Re: DEC
Route 9W Multi-Family Development
1530 Route 9W, Ulster, Ulster County, NY 12449
24PR08574

Avoidance Plan USN 11118000046 Locus 4

9W Multifamily Development 1A/1B PR#24PR08574 Lake Katrine, Town of Ulster, Ulster County
Management Summary

AREA OF POTENTIAL EFFECT
ROUTE 9W MULTI-FAMILY DEVELOPMENT

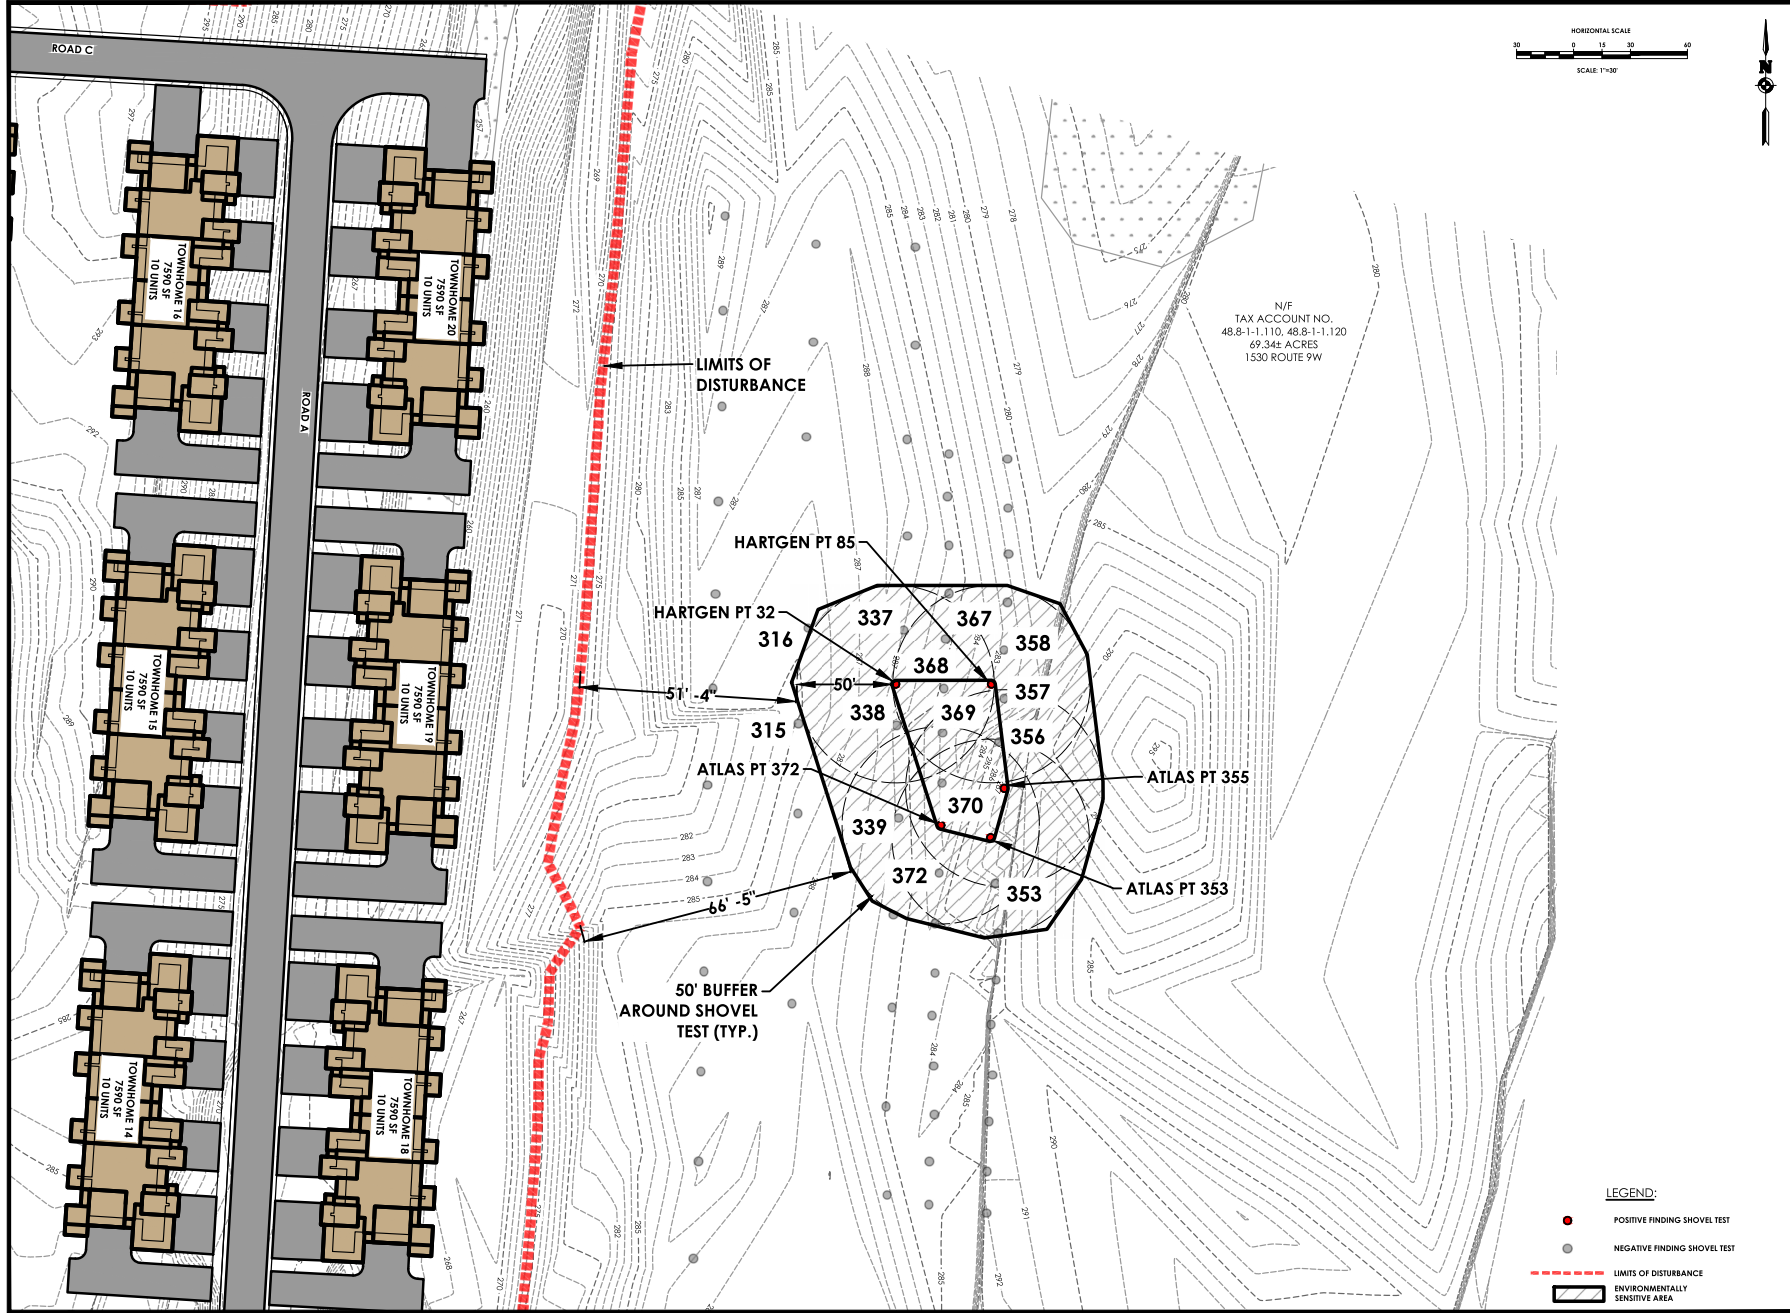
It is, therefore, the opinion of OPRHP that no properties, including archaeological and/or historic resources, listed in or eligible for the New York State and National Registers of Historic Places will be impacted by this project, **with the condition** that the attached Site Avoidance Plan for the The Precontact Locus 4 Site (USN 11118.000046) is adhered to.

Short-term Protective measures: 1) Fencing, construction controls, 50 foot buffer. The original site plan was modified to allow a 100 foot buffer from Locus 4.

- At a preconstruction meeting with the construction contractor, the person in charge shall be notified regarding the need to protect and avoid the archaeological site.
- The avoidance area (see attached Avoidance Plan Map) shall be indicated on the construction plans and identified as a “Environmentally Sensitive Area—No Access.”

It is recommended that the quarry site be avoided entirely and that at least a 50-foot (15.2m) buffer around the location be provided. In this circumstance, the client and engineers modified the site plan to include a 100-foot (30m) buffer. The site's boundary must be clearly delineated in the final construction plans and must be identified as an environmentally sensitive area with no access. Temporary fencing will need to be installed around the boundaries of the avoidance area prior to any clearing or construction activities within the APE and shall be maintained until construction has concluded. There will need to be preconstruction meetings in which people are made aware of the area needing to be protected and the existing landscape will need to be maintained.

11118.000046 precontact Locus 4 will be avoided with a minimum of a 50 foot boundary in all directions.
